259 Matterhorn Way

PSC DOCKET NO. 21-057-03
Looking East from DEU EXHIBIT B, page 4 of 10
SW side of 259.

259 Matterhorn Way

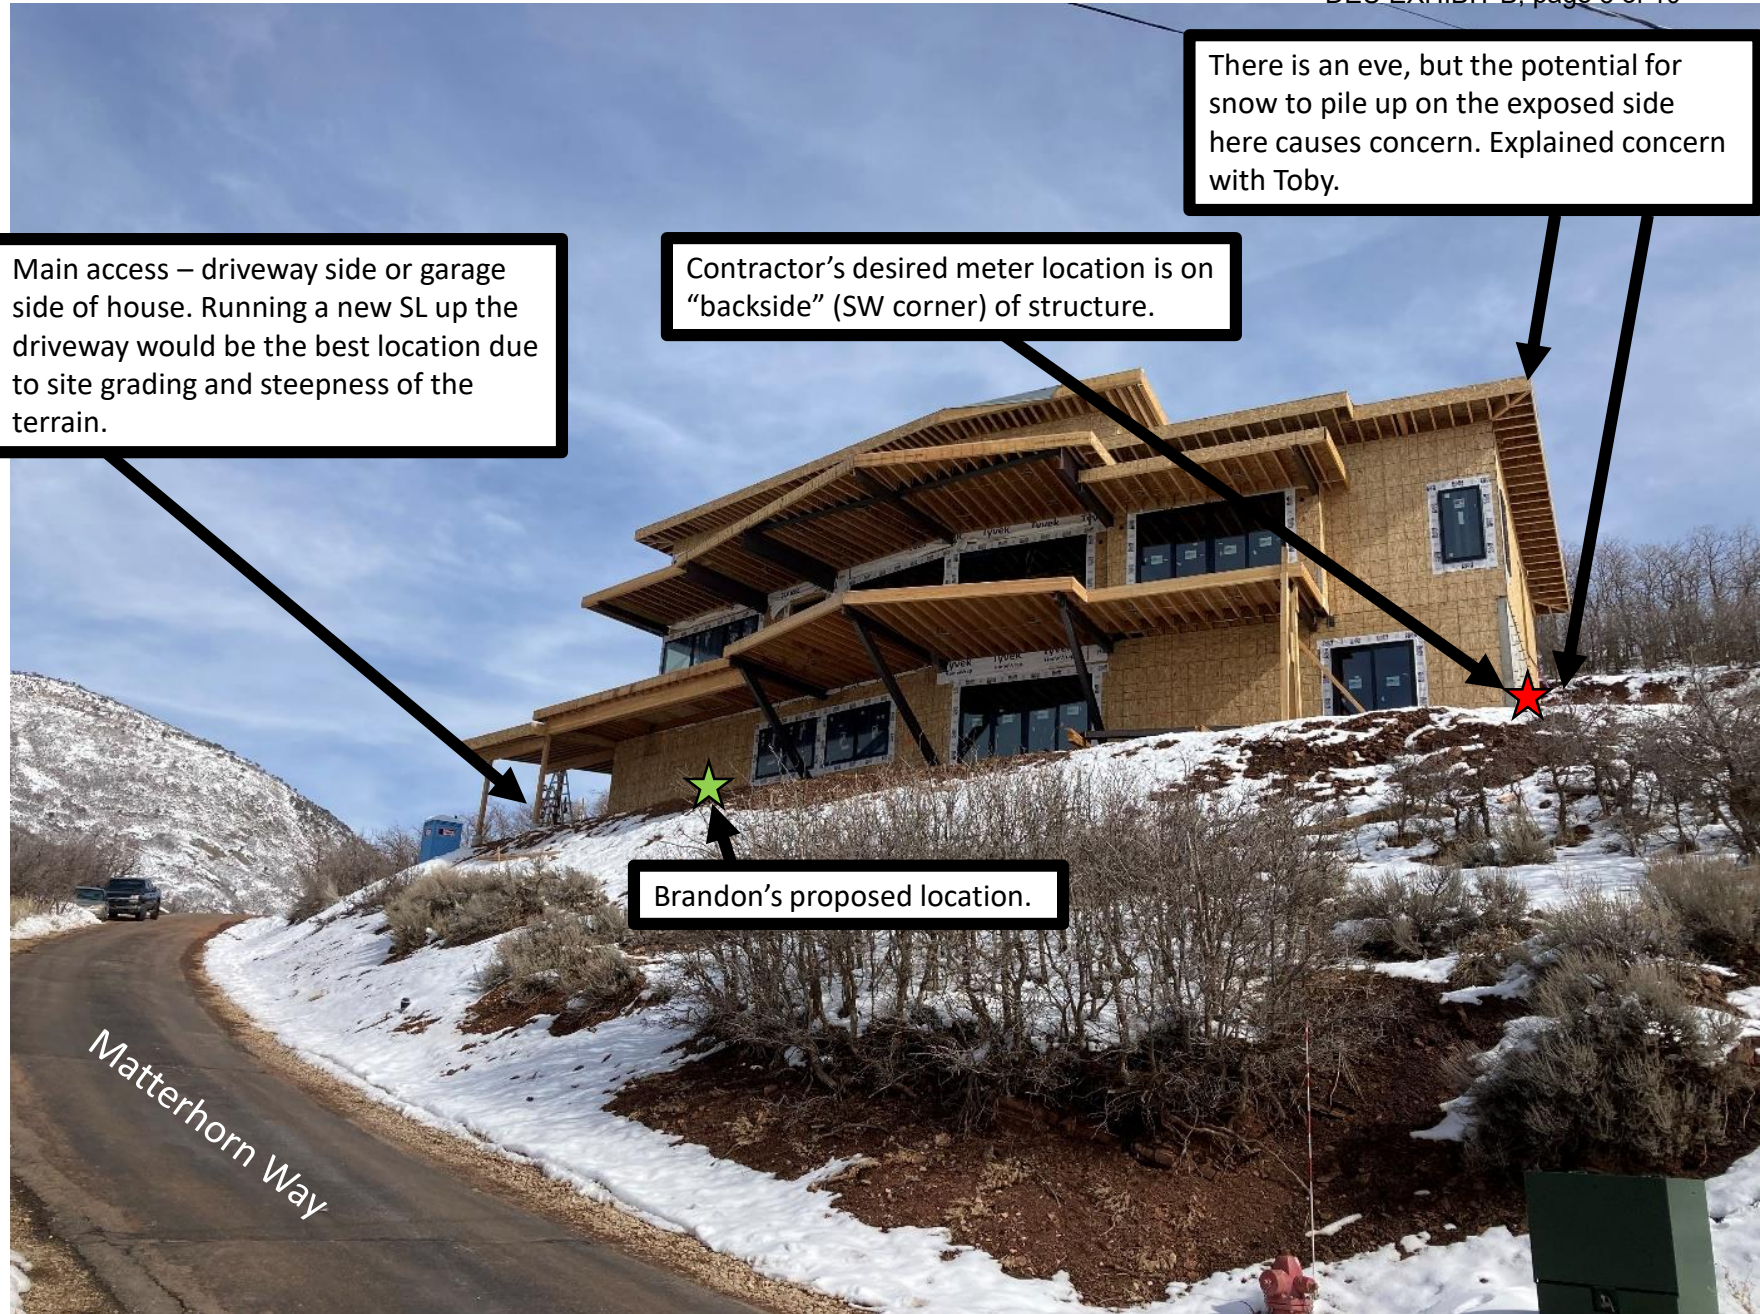
Please note site is extensively graded into hillside. The only access is from the driveway. The “Front” of structure should be considered garage side.

The uphill side of the structure would not be a good location. Issues with accessibility and we would see the deepest snow accumulation on this side as well.

Main access – driveway side or garage side of house. Running a new SL up the driveway would be the best location due to site grading and steepness of the terrain.

Contractor’s desired meter location is on “backside” (SW corner) of structure.

There is an eve, but the potential for snow to pile up on the exposed side here causes concern. Explained concern with Toby.

Brandon’s proposed location.

Northside 259,
looking South

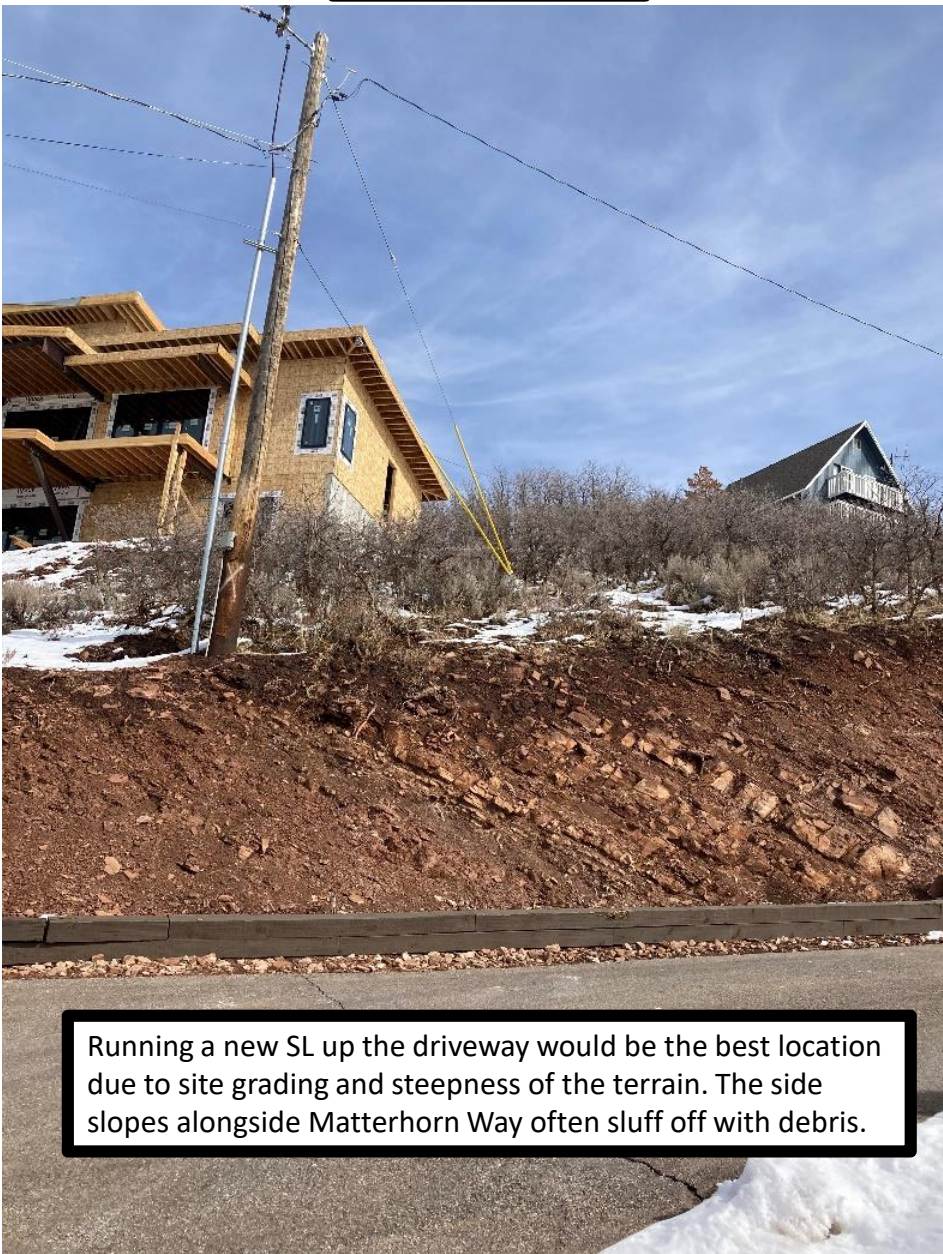
Looking South from NW side of 259.

Steep terrain

Running a new SL up the driveway would be the best location due to site grading and steepness of the terrain. The side slopes alongside Matterhorn Way often sluff off with debris.

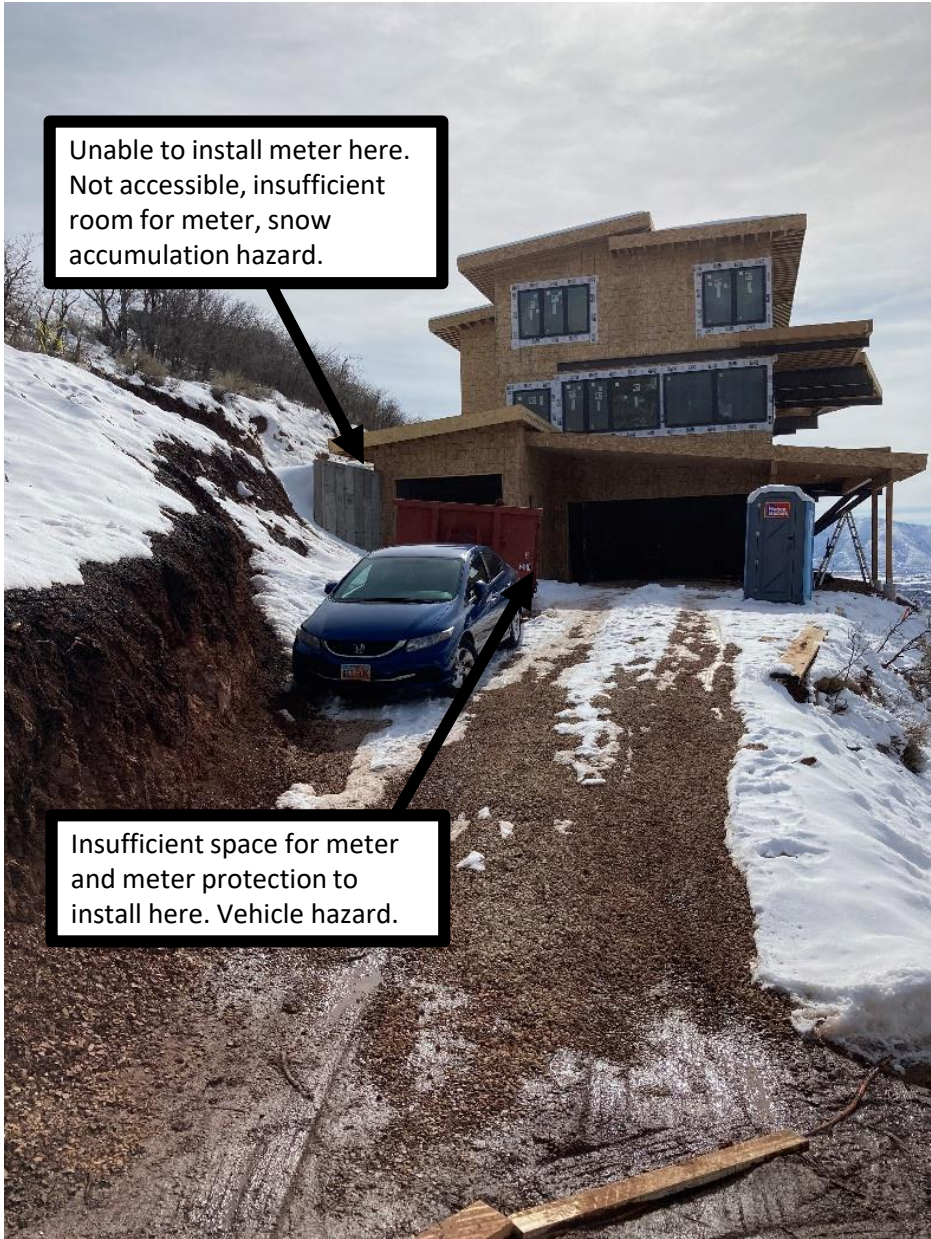
Unable to install meter here.
Not accessible, insufficient
room for meter, snow
accumulation hazard.

Insufficient space for meter
and meter protection to
install here. Vehicle hazard.

Toby explained this retaining wall would be extended further down the driveway. Very steep through this space where the snow is shown.

NW Corner of 259 looking South.

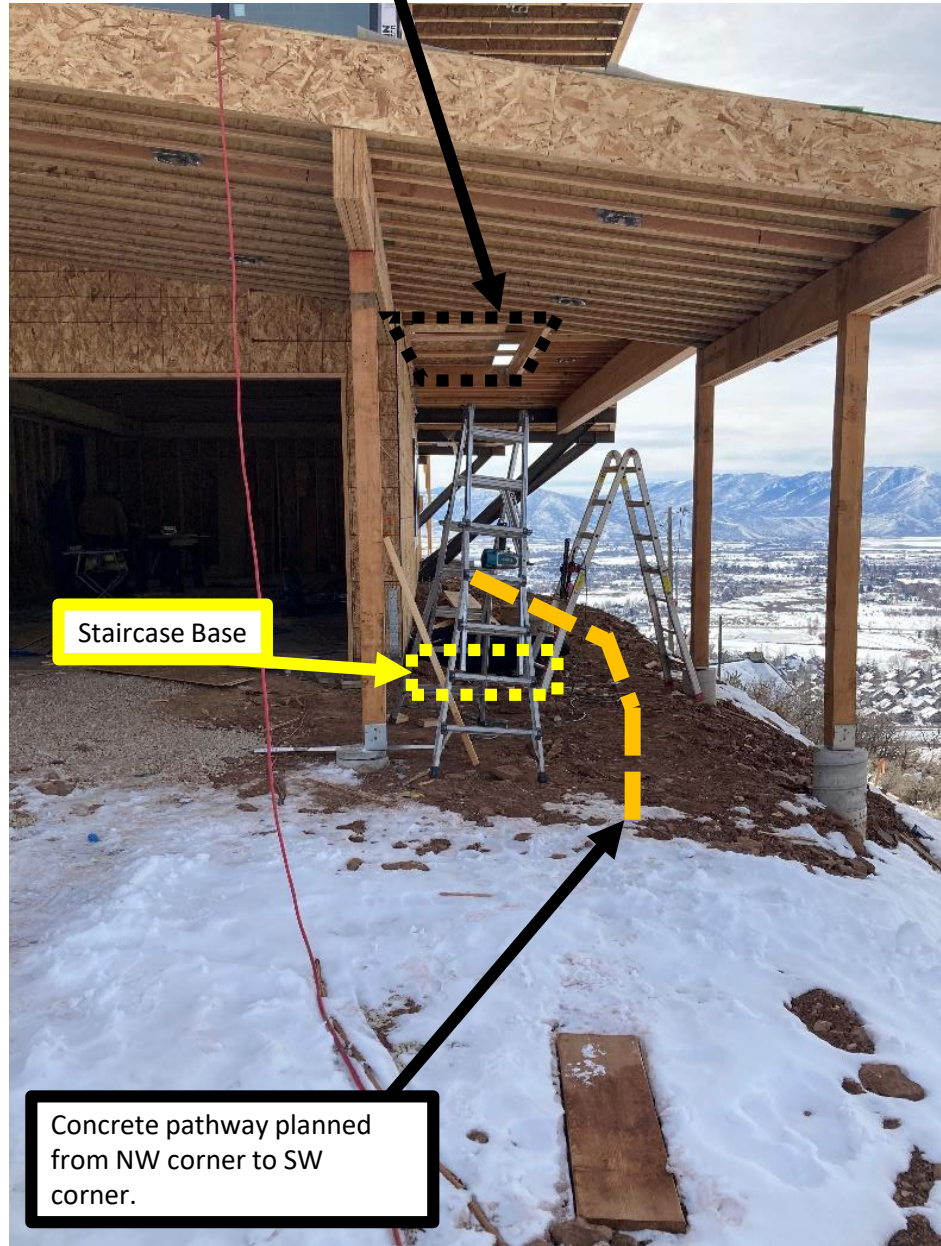
Unable to install meter here on the backside of the wall on garage. It would be inaccessible, have insufficient room for meter, and a snow accumulation hazard.

Concrete pathway planned from NW corner to SW corner.

Insufficient space for meter and meter protection to install here. Vehicle hazard.

SW Corner of 259 looking North.

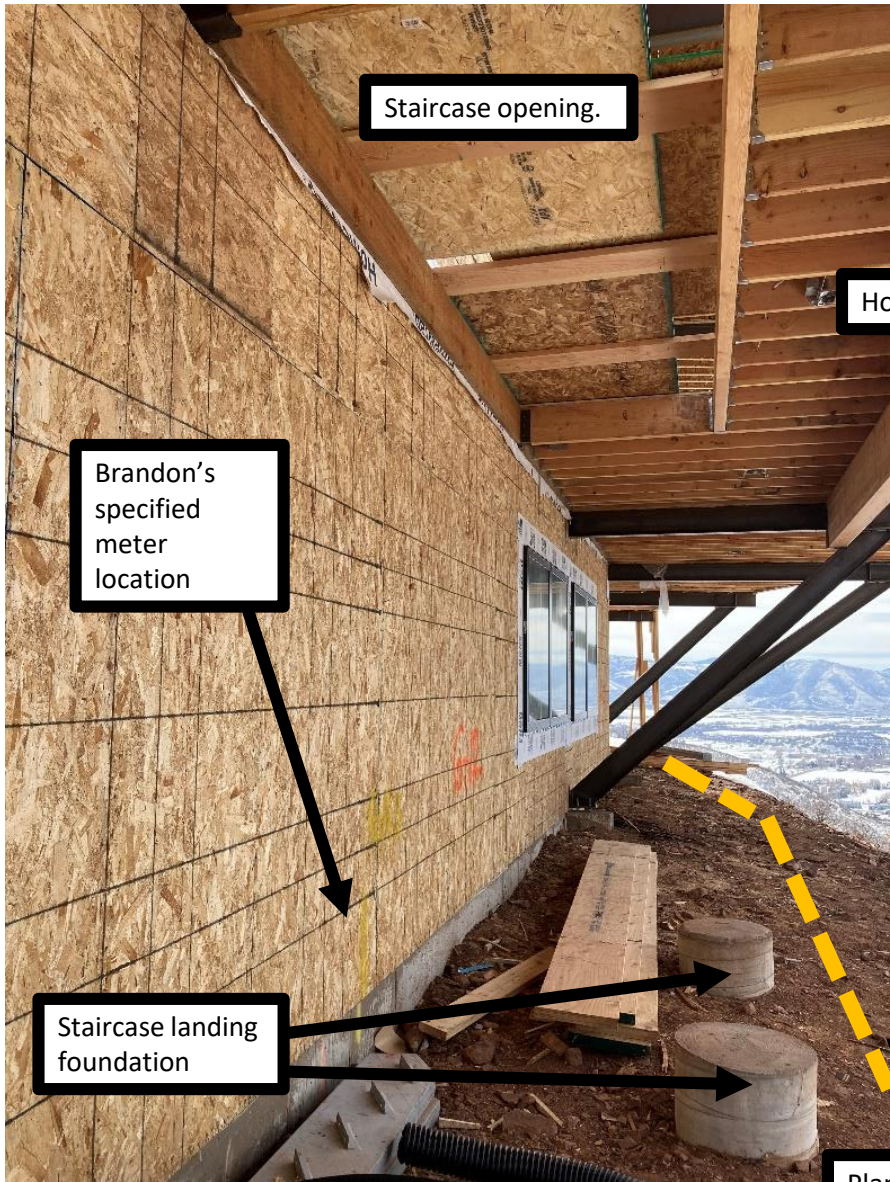
Brandon has spoken with the Contractor previously about not being able to install a meter at this location. It is located on the backside of the structure. There is also snow accumulation hazards, accessibility concerns with deep snow and the terrain.

Brandon has spoken with the Contractor previously about not being able to install a meter at this location. Same concerns as noted above.

Brandon's
specified
meter
location

I would recommend sticking
the meter in this general
area since the landing of the
stairs will limit accessibility
to the meter.

I asked Toby if the homeowners main concern with this location was aesthetics of the meter. He indicated that it was. I suggested he could build a well ventilated structure to disguise the meter and that we could send him our specs on that. I told him the door or the structure would need to have enough clearances around the meter so we could maintain it.
